### 2007 Big Twin Clutch Release Plates

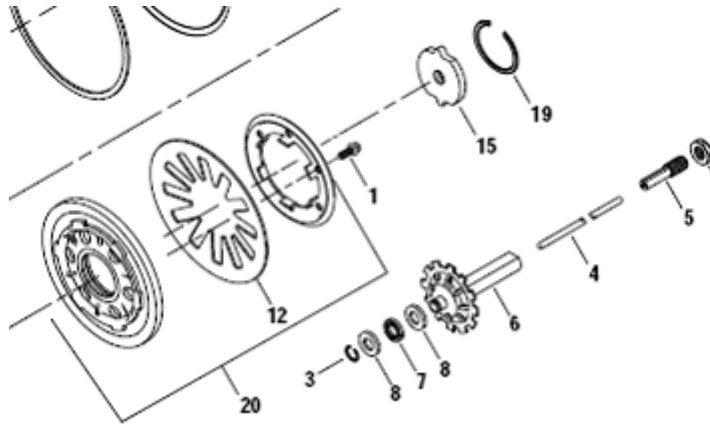
Between January and July of 2007 some Twin Cam Models were assembled with a Clutch Release Plate, (p/n 37903-90) that could have the adjuster screw threads not machined perpendicular to the plate. This would cause the adjuster screw (item 5) to not sit square in the Release Plate (item 15).

If the adjuster screw was held straight as the release plate was installed in the pressure plate, it could cause the release plate to be cocked, and the retaining ring may not be fully seated in its groove all the way around. However, if the plate and snap-ring are installed correctly the adjuster screw may not be contacting the push rod properly.

These conditions may result in difficulty adjusting the clutch release or a dragging clutch. If you experience either, please look carefully at the adjuster & release plate assembly for the condition shown below:
